UNITED STATES PATENT AND TRADEMARK OFFICE

Office Action Summary

SIMPLIFIED "T" INTERCHANGE DESIGN

Figure 7

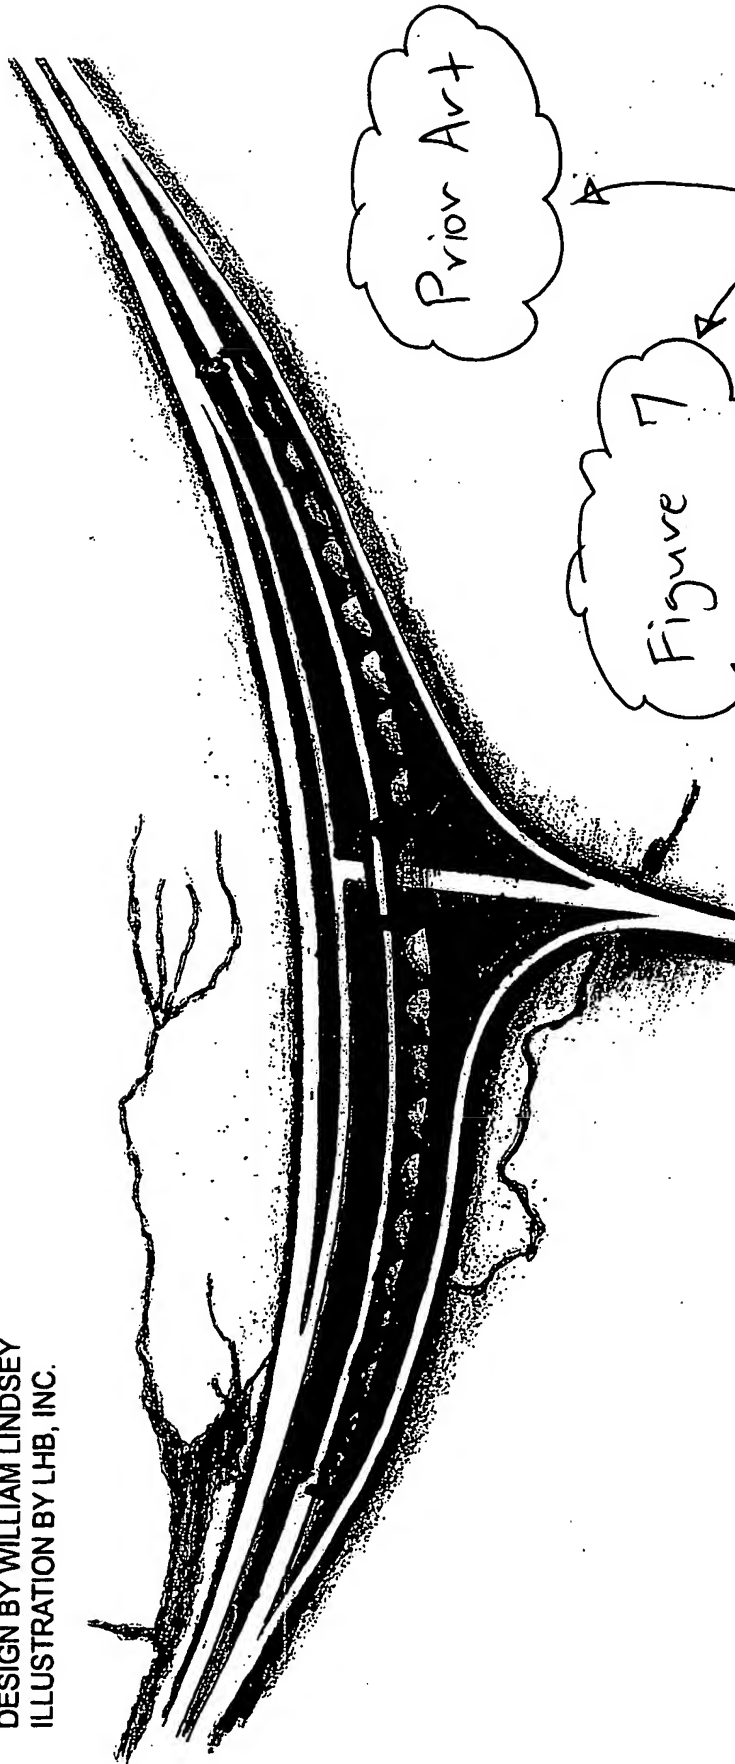
1. Figure 7 (submitted with the applicant's response dated 4/13/06) should be designated by a legend such as --Prior Art-- because only that which is old is illustrated. Additionally, the figure must be labeled --Figure 7--. The re-submitted drawing must be labeled --Prior Art-- and --Figure 7-- in order to be approved. See MPEP § 608.02(g). Corrected drawings in compliance with 37 CFR 1.121(d) are required in reply to the Office action to avoid abandonment of the application. The replacement sheet(s) should be labeled "Replacement Sheet" in the page header (as per 37 CFR 1.84(c)) so as not to obstruct any portion of the drawing figures. If the changes are not accepted by the examiner, the applicant will be notified and informed of any required corrective action in the next Office action. The objection to the drawings will not be held in abeyance.

THESE
LABELS ARE
REQUIRED IN
THE RESUBMITTAL

NOT APPROVED
